COMMUNITY DEVELOPMENT

PLANNING COMMISSION

AGENDA ITEM: 3. Public Hearing – Updated St. Croix Heights Preliminary Plat

PREPARED BY: Carlos Espinosa

PRELIMINARY SITE PLAN

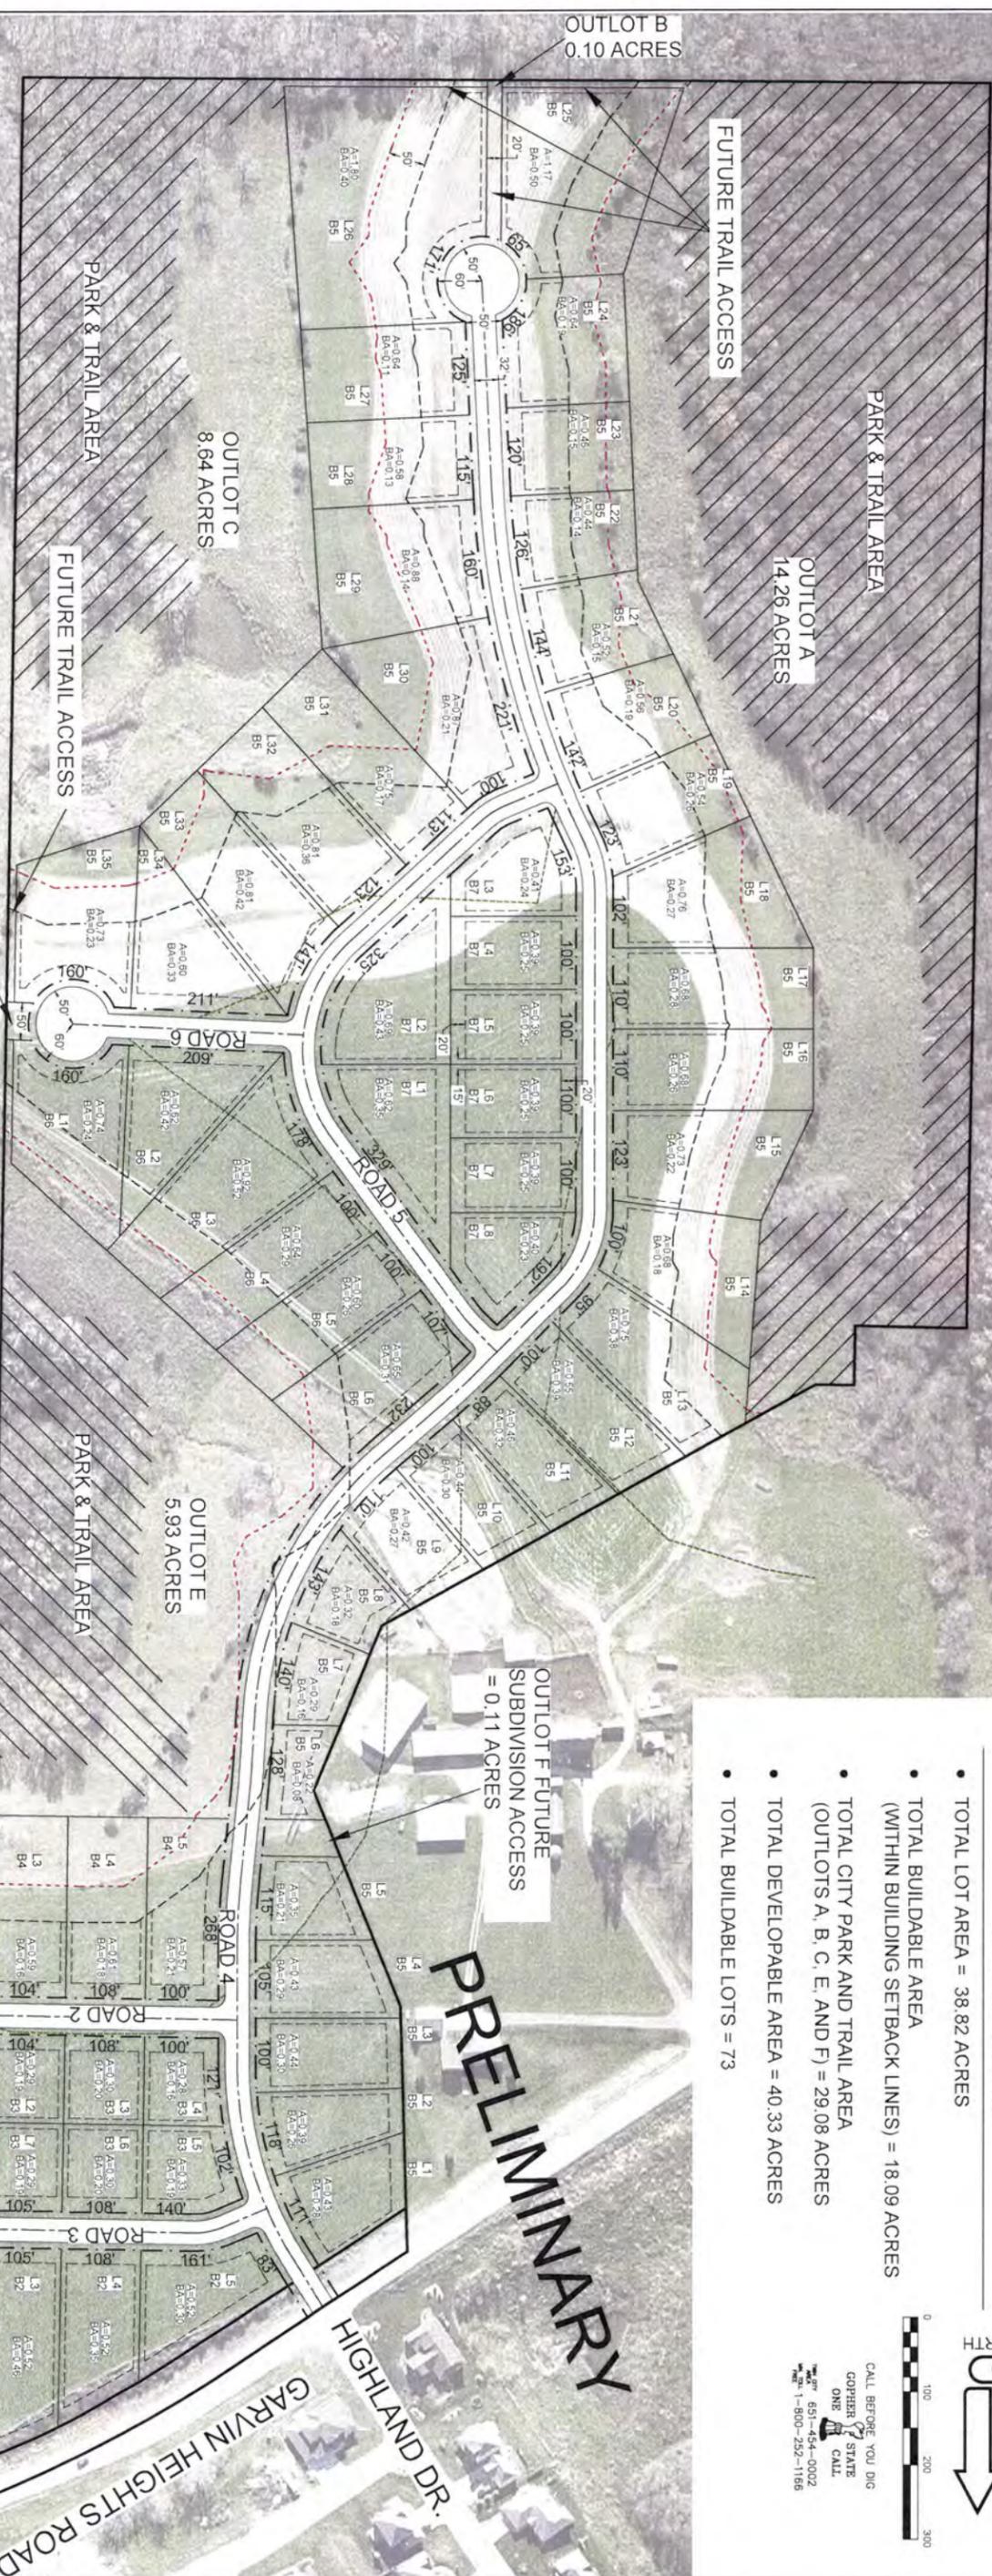
As noted above this subdivision contains bluffland areas. The City's Bluffland Ordinance prohibits development below tops of bluffs. The top of bluff is shown by the dotted red line on Attachment C, Exhibit C Sheet 2. In addition, the regulations require Planning Commission approval of the proposed location of stormwater facilities (ponds) in bluffland areas (Attachment C, Exhibit D). The standards for approval are the following:
